## HISTORIC AND DESIGN REVIEW COMMISSION

**HDRC CASE NO:** 2019-112  
**ADDRESS:** 414 BURLESON ST  
**LEGAL DESCRIPTION:** NCB 520 BLK 24 LOT 4 & E 52.09 FT OF 9  
**ZONING:** R-5, H  
**CITY COUNCIL DIST.:** 2  
**DISTRICT:** Dignowity Hill Historic District  
**APPLICANT:** Peter Dewitt/Adapt Architecture and Construction  
**OWNER:** Colby Huggler  
**TYPE OF WORK:** Construction of a 1-story, single family residential structure  
**APPLICATION RECEIVED:** March 01, 2019  
**60-DAY REVIEW:** April 30, 2019  
**CASE MANAGER:** Edward Hall

The applicant is requesting a Certificate of Appropriateness for approval to construct a one story, single family residential structure on the vacant lot at 414 Burleson, located within the Dignowity Hill Historic District. The proposed new construction will also feature a detached, rear accessory structure.

**1 SITE PLAN / ROOF PLAN**  
SCALE: 1"=10'-0"

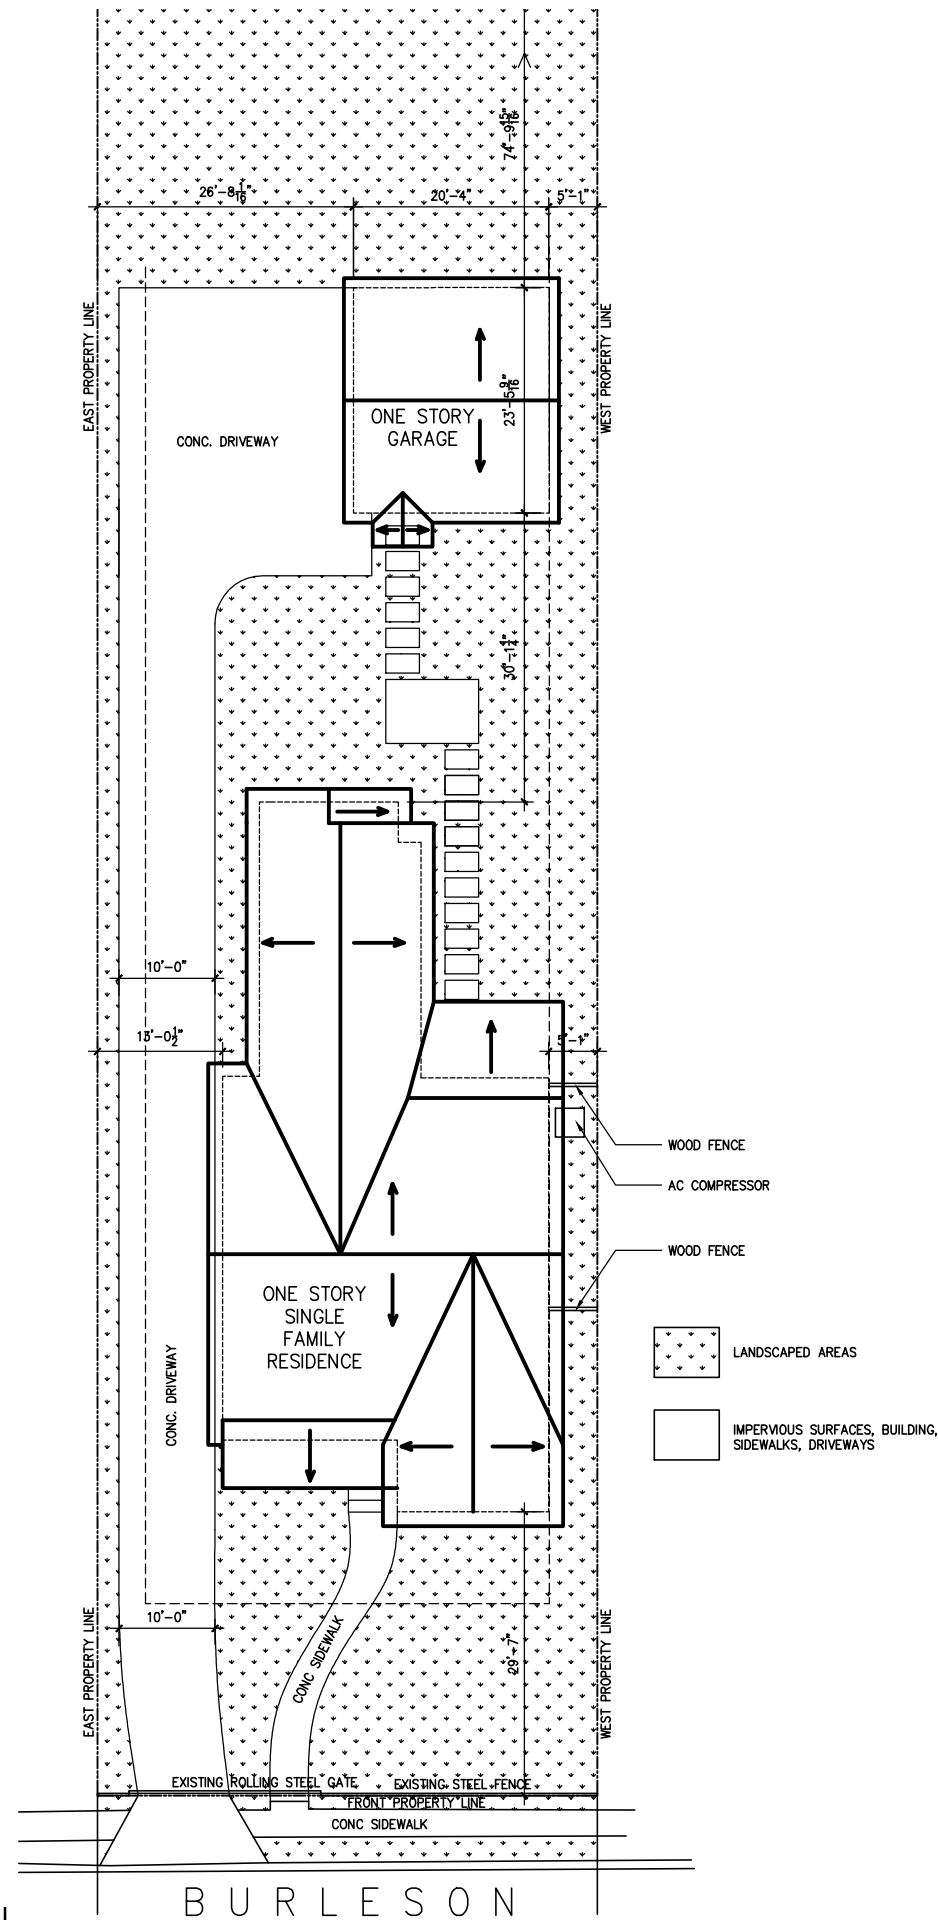
- m. DRIVEWAY – The applicant has proposed a driveway on the east side of the property. Historic structures on this block feature driveways on the east side of the lots. The proposed driveway location is consistent with the Guidelines. Staff finds that the width should not exceed ten (10) feet in width, per the Guidelines for Site Elements. The existing apron may be modified to align with the proposed driveway.

- n. MECHANICAL EQUIPMENT – Per the Guidelines for New Construction 6., all mechanical equipment should be screened from view at the public right of way. The applicant is responsible for screening all mechanical equipment where it cannot be viewed from the public right of way.

**1 FLOOR PLAN**  
SCALE: 1/4"=1'-0"

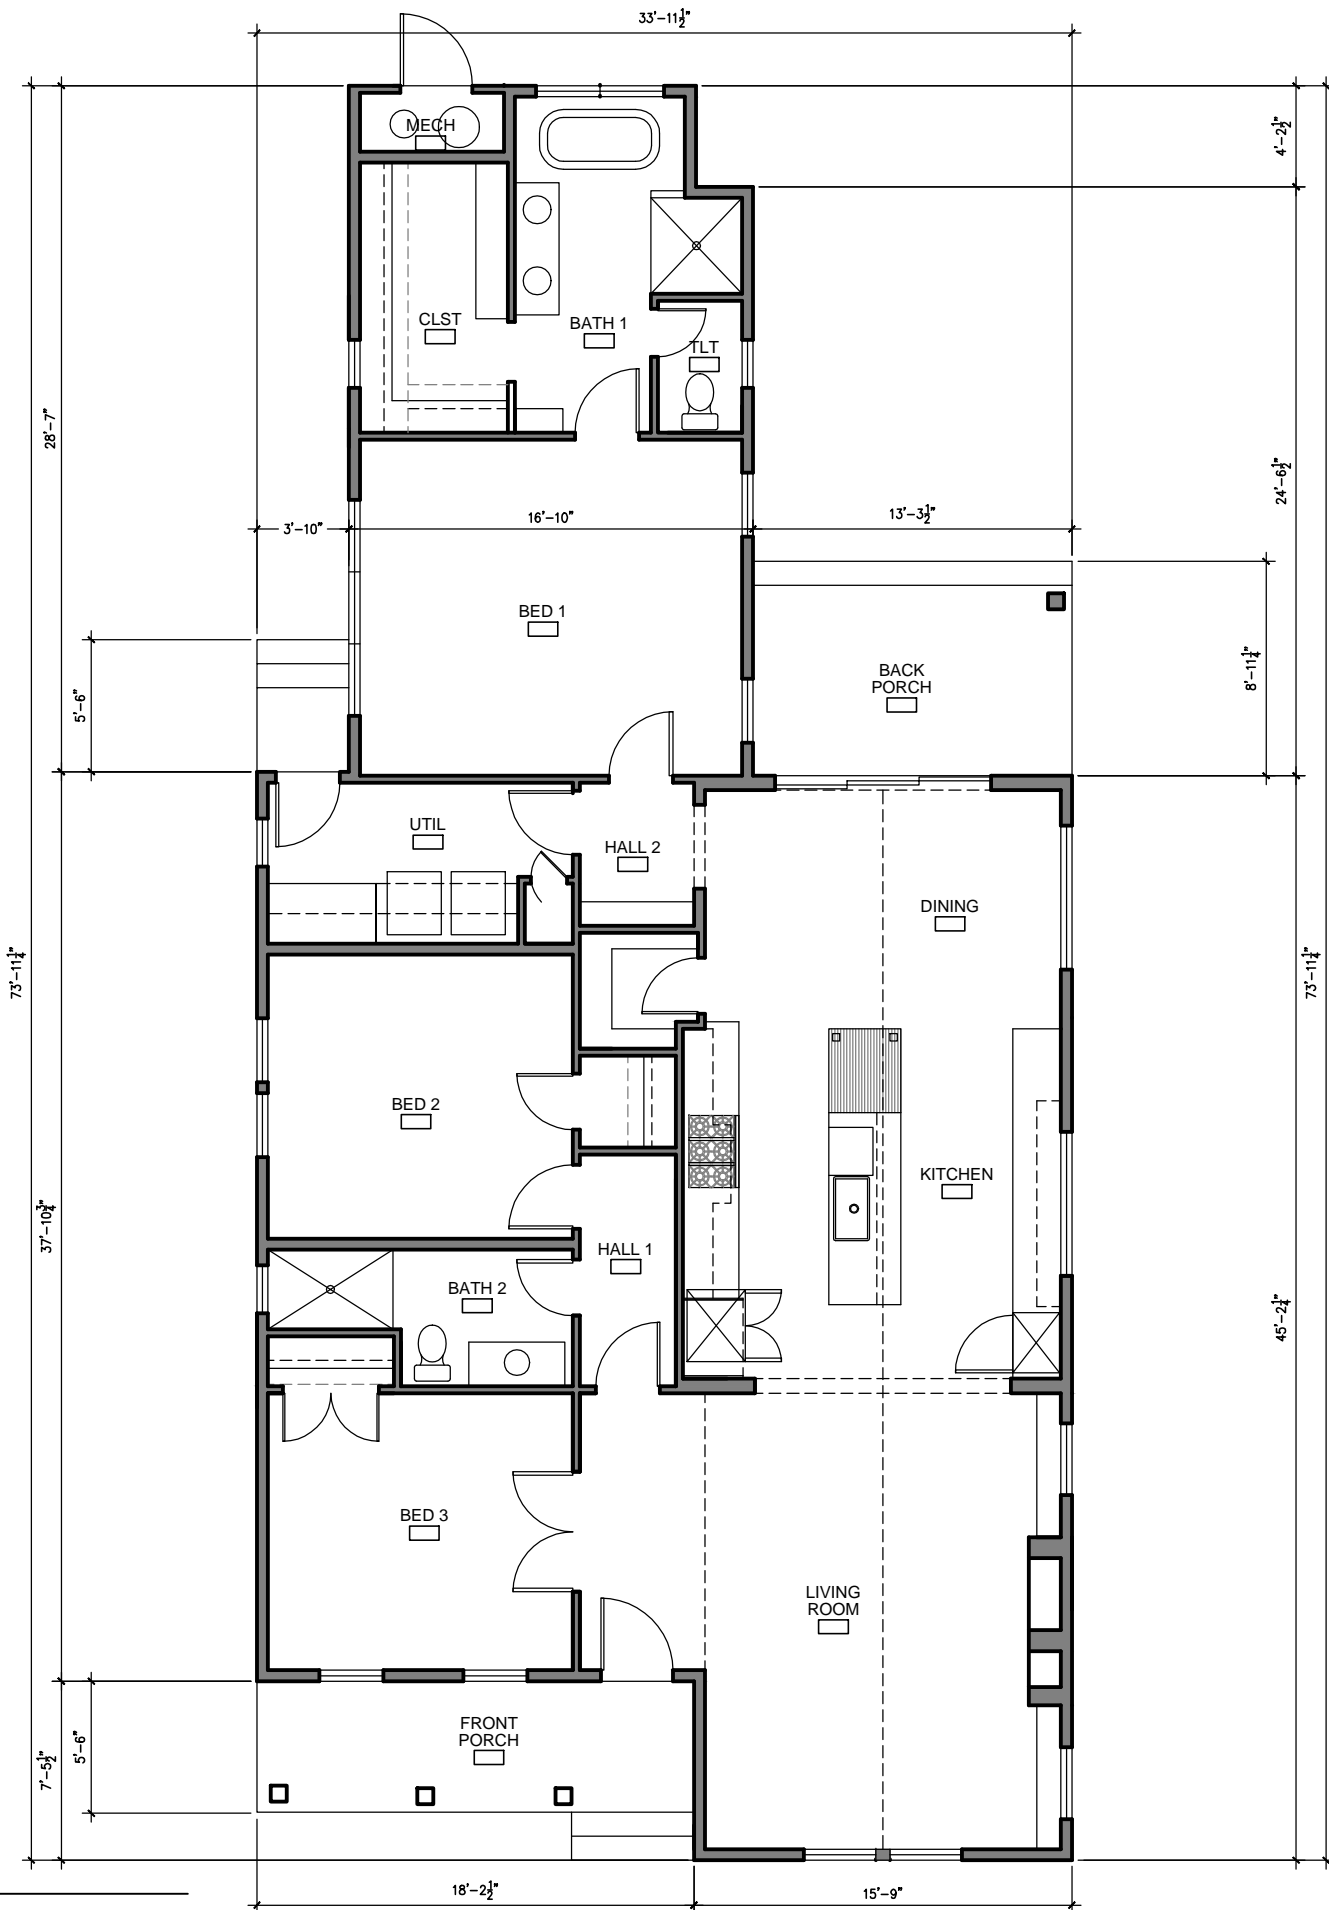
COMMENTS/CONCERNS: Made changes based on previous staff comments. Stucco to siding, change to roof ridge. Lot is vacant. Demonstrated front setbacks of adjacent properties. CF - front-facing porch would be appropriate. PD - many houses have inset / side porch. EG - front bay window places emphasis on front. CF - Front setback should meet or exceed adjacent houses. Might be appropriate. Inset porches are not common on street.

Front room / porch should be reconfigured to be more in keeping with established pattern. Or extend porch across full width of house. Depth of porch not as much as an issue.

EXT/ ELEVATIONS

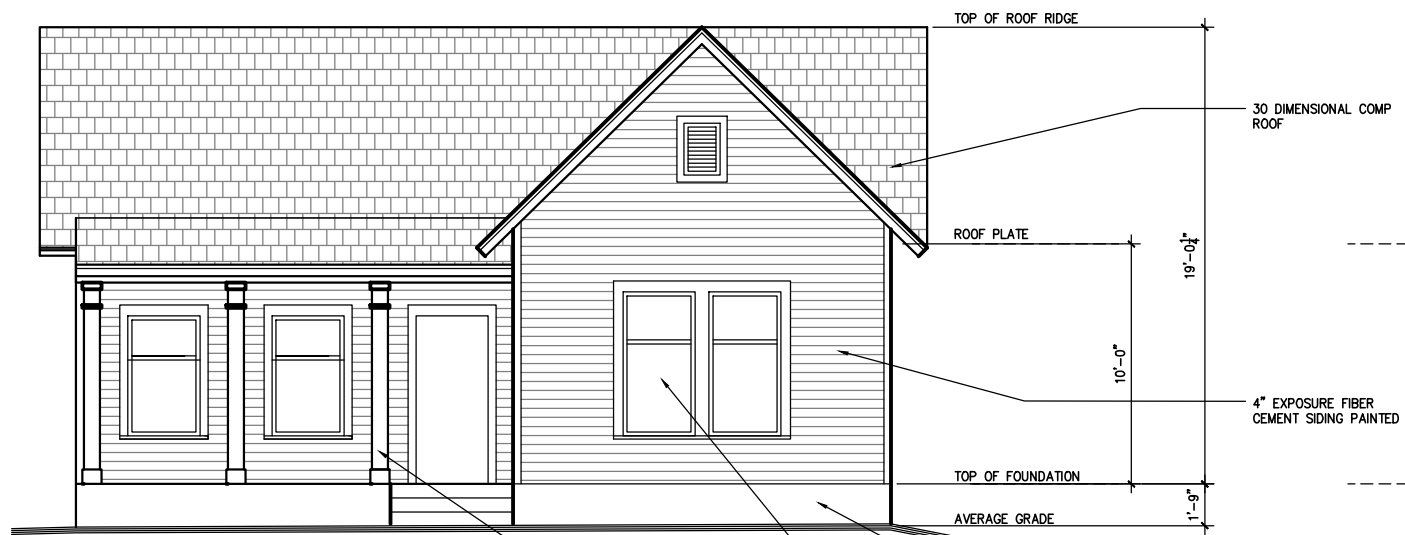
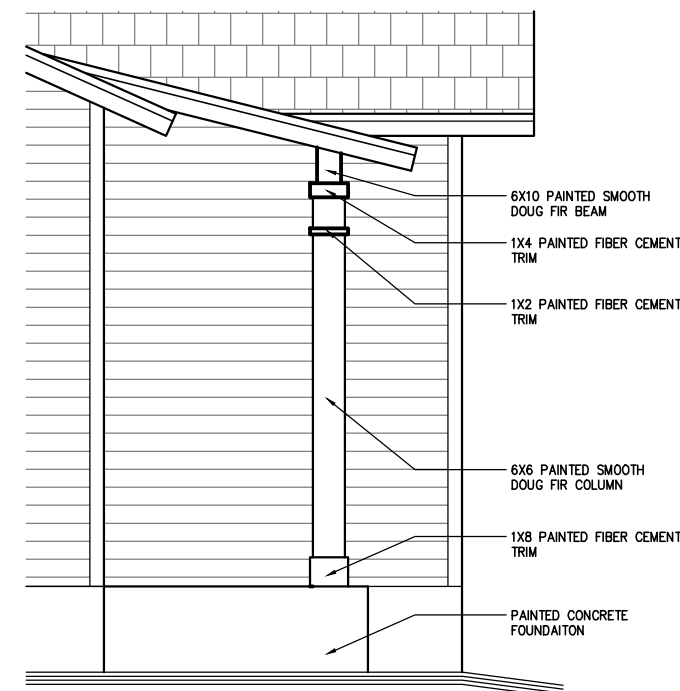
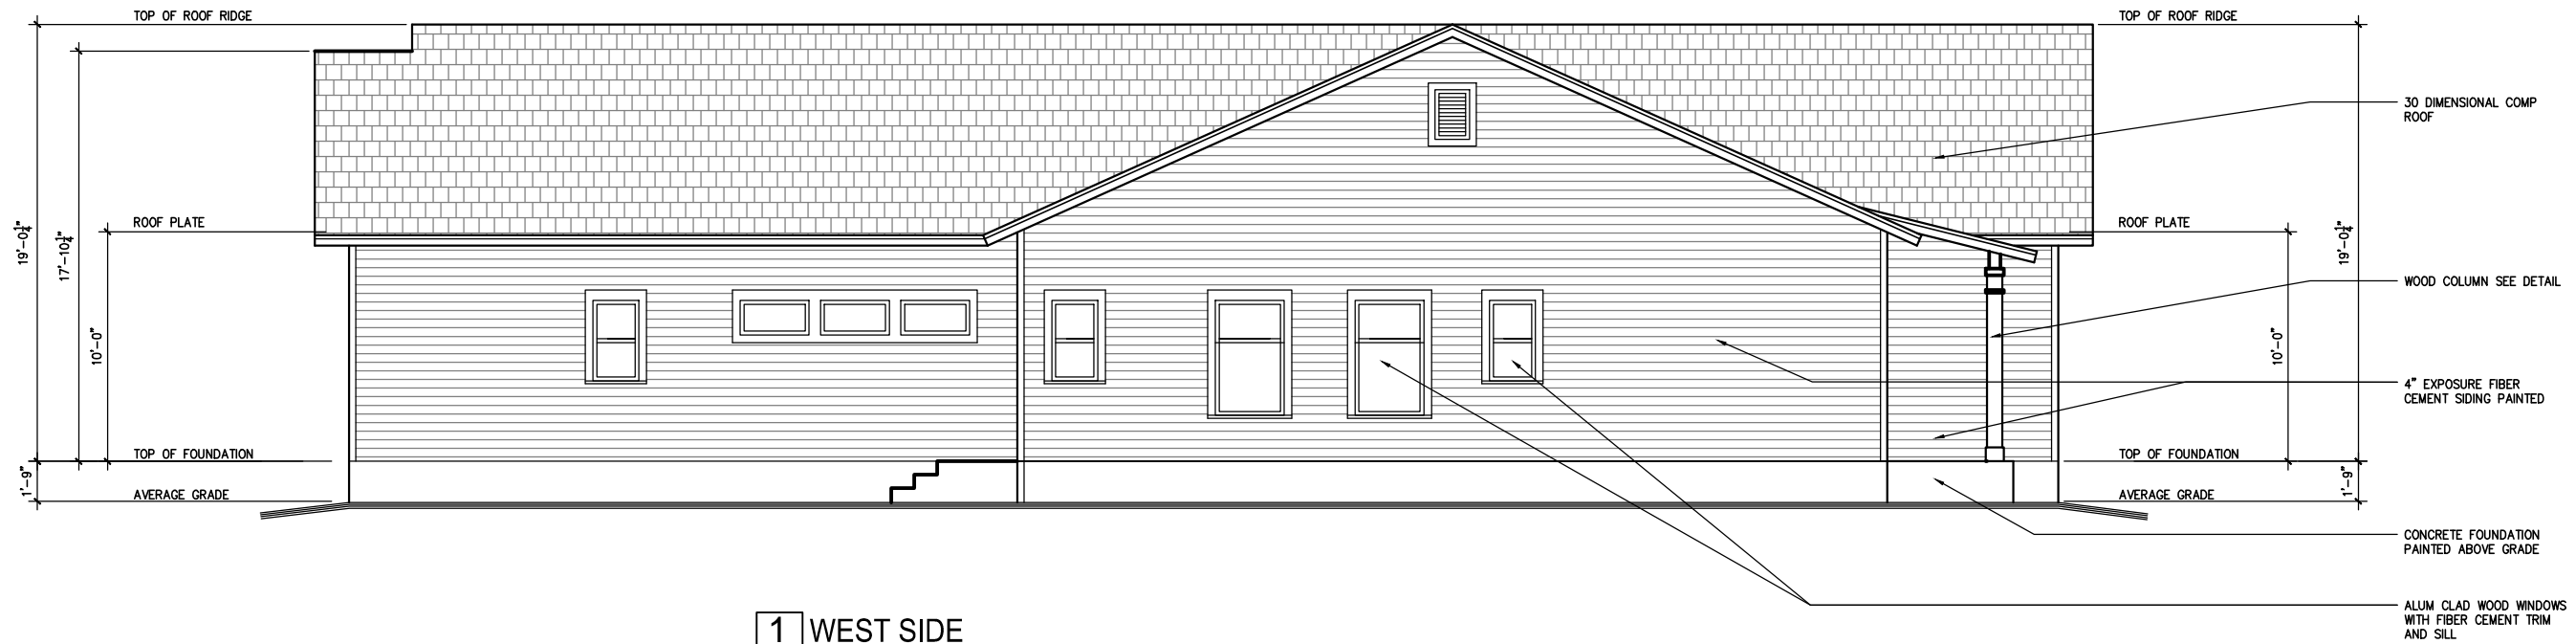
- i. MATERIALS – The applicant has proposed materials that include composite siding with a four (4) inch exposure,

an asphalt shingle roof and aluminum clad wood windows. Staff finds the proposed materials to be appropriate and consistent with the Guidelines. The proposed composite siding should feature a smooth finish.

- j. WINDOW MATERIALS – As noted in finding i, the applicant has proposed aluminum clad wood windows. Staff finds the proposed window materials to be appropriate. The proposed windows should feature an inset of two (2) inches within facades and should feature profiles that are found historically within the immediate vicinity. Meeting rails should be no taller than 1.25” and stiles no wider than 2.25”. White manufacturer’s color is not allowed, and color selection must be presented to staff. There should be a minimum of two inches in depth between the front face of the window trim and the front face of the top window sash. This must be accomplished by recessing the window sufficiently within the opening or with the installation of additional window trim to add thickness. Window trim must feature traditional dimensions and an architecturally appropriate sill detail. Window track components must be painted to match the window trim or concealed by a wood window screen set within the opening.

- i. That the proposed aluminum clad wood windows feature an inset of two (2) inches within facades and should feature profiles that are found historically within the immediate vicinity. Meeting rails should be no taller than 1.25” and stiles no wider than 2.25”. White manufacturer’s color is not allowed, and color selection must be presented to staff. There should be a minimum of two inches in depth between the front face of the window trim and the front face of the top window sash. This must be accomplished by recessing the window sufficiently within the opening or with the installation of additional window trim to add thickness. Window trim must feature traditional dimensions and an architecturally appropriate sill detail. Window track components must be painted to match the window trim or concealed by a wood window screen set within the opening.
